UNITED STATES
NUCLEAR REGULATORY COMMISSION
WASHINGTON, D. C. 20555

SUBJECT: NRC REQUIREMENTS FOR AUXILIARY FEEDWATER SYSTEMS AT PRAIRIE ISLAND
NUCLEAR GENERATING PLANT, UNITS 1 AND 2

PRAIRIE ISLAND 1 & 2 AUXILIARY FEEDWATER SYSTEM

Auxiliary Feedwater System
Prairie Island
Figure 1

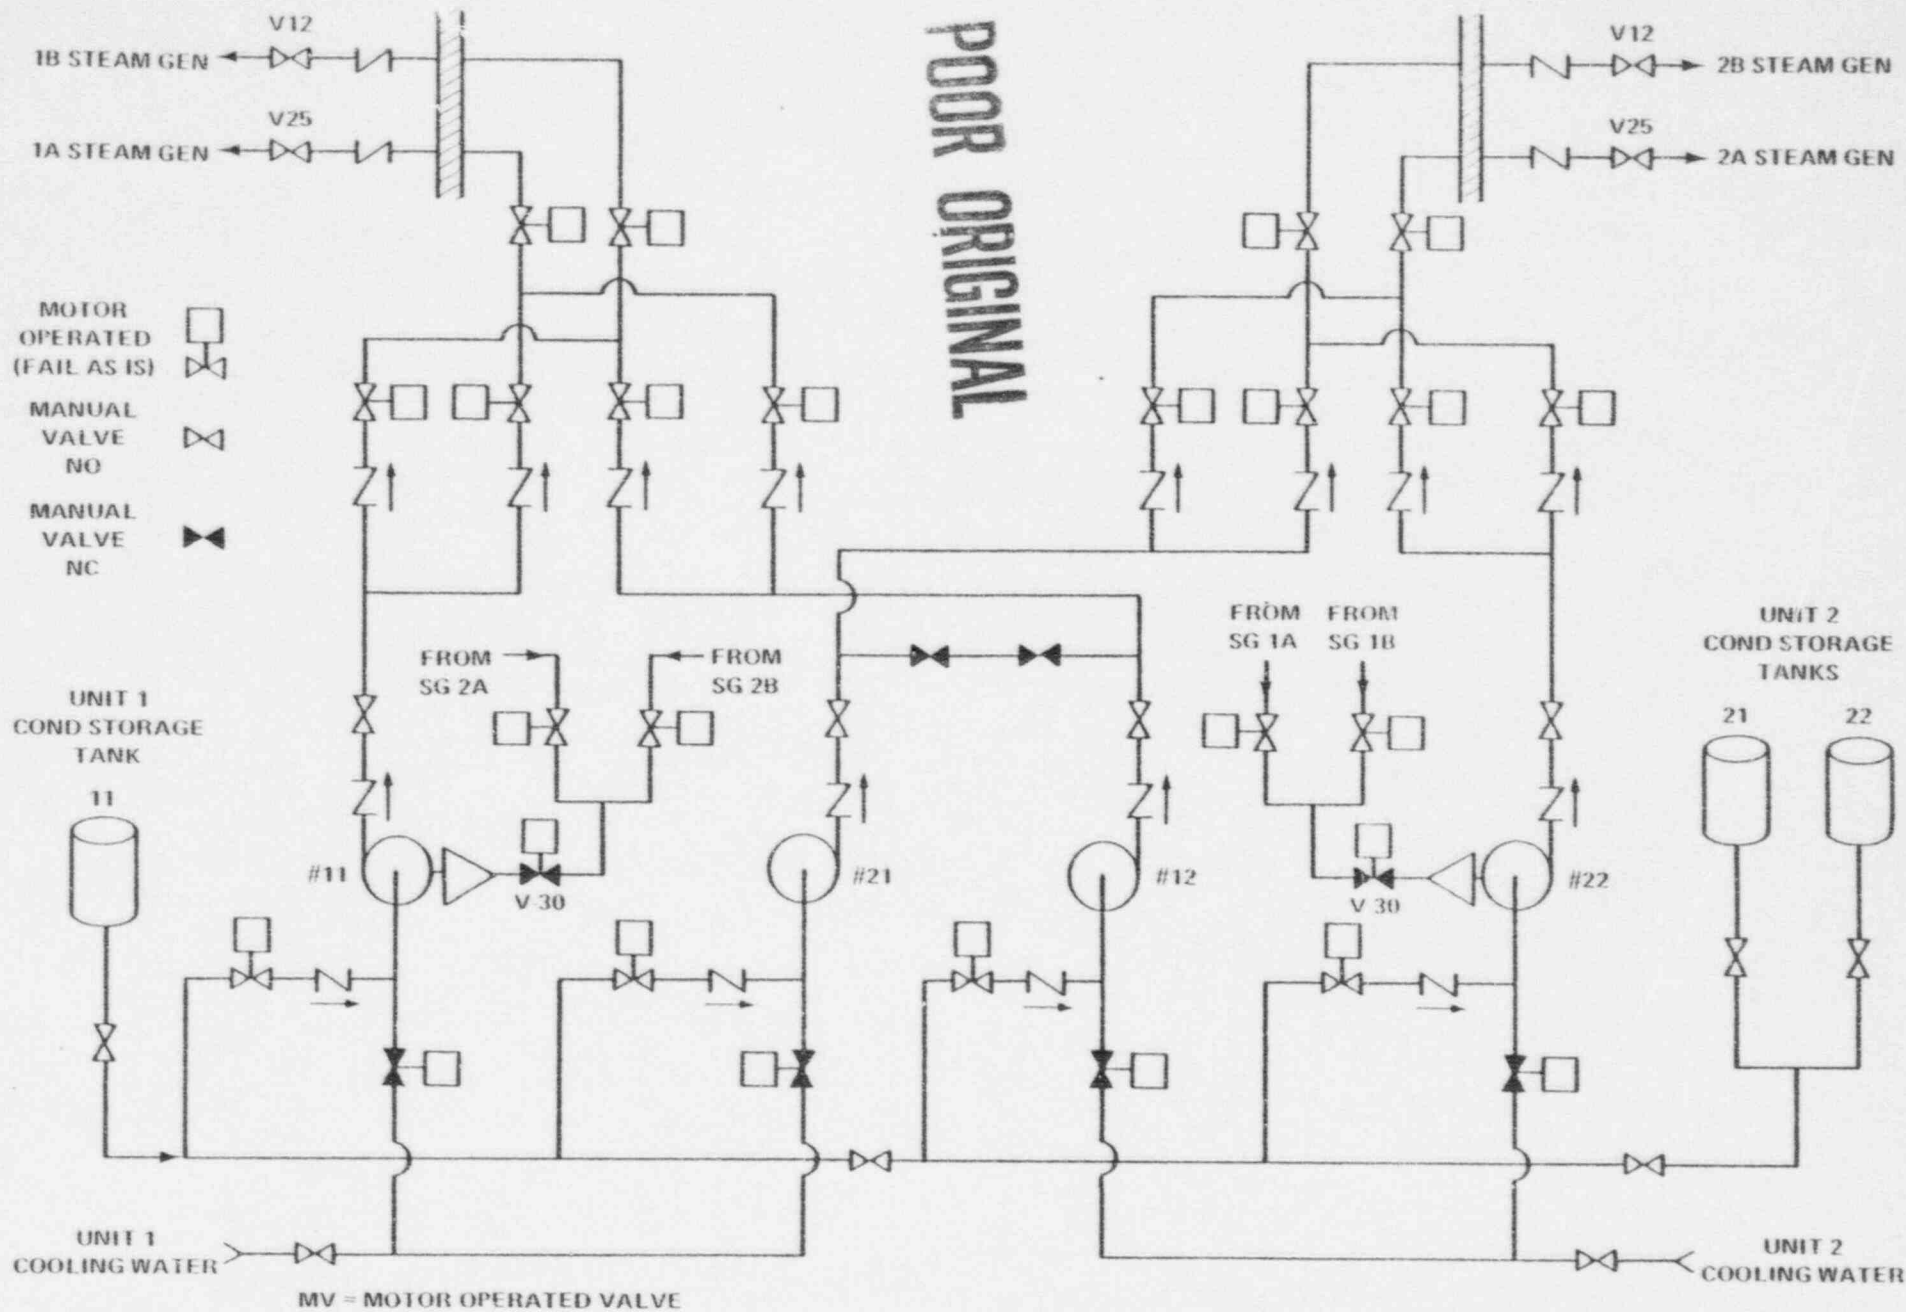
A dominant failure mode of the AFWS for this transient is assessed to be the blockage of flow to the two steam generators due to inadvertent closure of two manual valves in the pump discharge lines inside containment. These valves could possibly be closed prior to the AFWS demand because of, for example, a personnel error in failing to reopen them after maintenance on the AFWS. Because these valves do not have remote position indication and are located inside the containment, there could be a considerable delay in gaining access to and reopening of the valves after an AFWS demand. However, the licensee states that any inadvertent closure of these valves would be detected prior to reactor startup or at least before the reactor exceeds 2% power since (a) plant startup procedures require a valve alignment check to verify the AFWS flow path and (b) the AFWS is used during normal plant startup to maintain steam generator water level

The principal dependency found in this evaluation is the common-cause failure of all trains due to closure of the manual valves in the two AFWS discharge lines.

2. Recommendation GS-2 - The licensee should lock open single valves or multiple valves in series in the AFW system pump suction piping and lock open other single valves or multiple valves in series that could interrupt all AFW flow, including the manual valves V12 and V25 inside containment. Monthly inspections should be performed to verify that these valves are locked and in the open position. These inspections should be proposed for incorporation into the surveillance requirements of the plant Technical Specifications. See Recommendation GL-2 for the longer-term resolution of this concern.
